1. DETAILS OF THE DEVELOPMENT

Ref: 21/06269/PRE
Location: Croydon Park Hotel, 7 Altyre Road, Croydon, CR9 5AA
Ward: Addiscombe West
Description: To demolish the existing buildings and erect a development to provide approximately 450 residential units (Use Class C3, as build to rent), internal and external amenity space, together with associated wheelchair accessible vehicle parking, cycle parking, landscaping, play areas and works.
Applicant: Amro Flemyn Croydon Limited
Agent: Newsteer Real Estate Advisers
Case Officer: Georgina Betts

2. PROCEDURAL NOTE

Image 16: Green corridor to Altyre Road

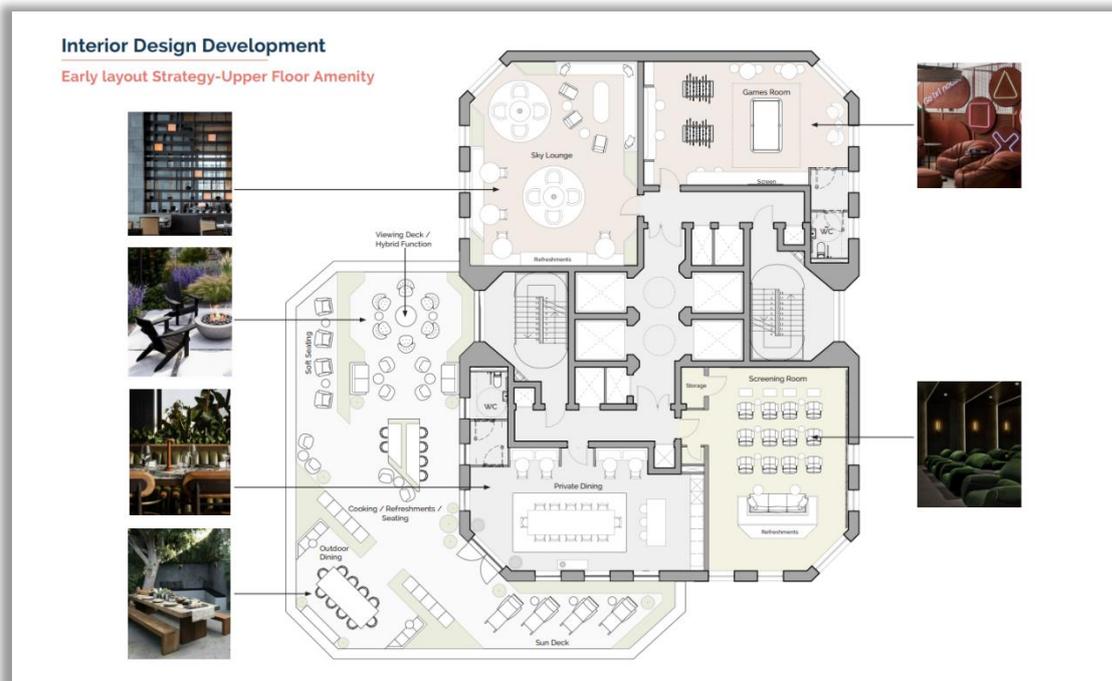
6.21 The layout of the proposal allows for an improvement to the public realm to the north and western boundaries. The Hazledean Road frontage is currently a combination of public car park and end elevation of the vacant hotel building, whilst the Altyre Road frontage was used for the servicing of the former hotel, so there are opportunities for improvements as a result of the scheme. The proposal seeks to incorporate green corridors to Altyre Road and an improved public realm/square to the north-eastern corner of the site. Further extending this green corridor the length of Altyre Road would enable a green link between East Croydon Station and Park Hill and tie in with wider Green Grid planning. This wider public benefit and improvement to the street scape would help mitigate some of the impacts to existing neighbours caused by the scale of development. A multi-use communal amenity area is provided centrally within the site and would offer environmental benefits over and above the existing provision. Officers support this approach.
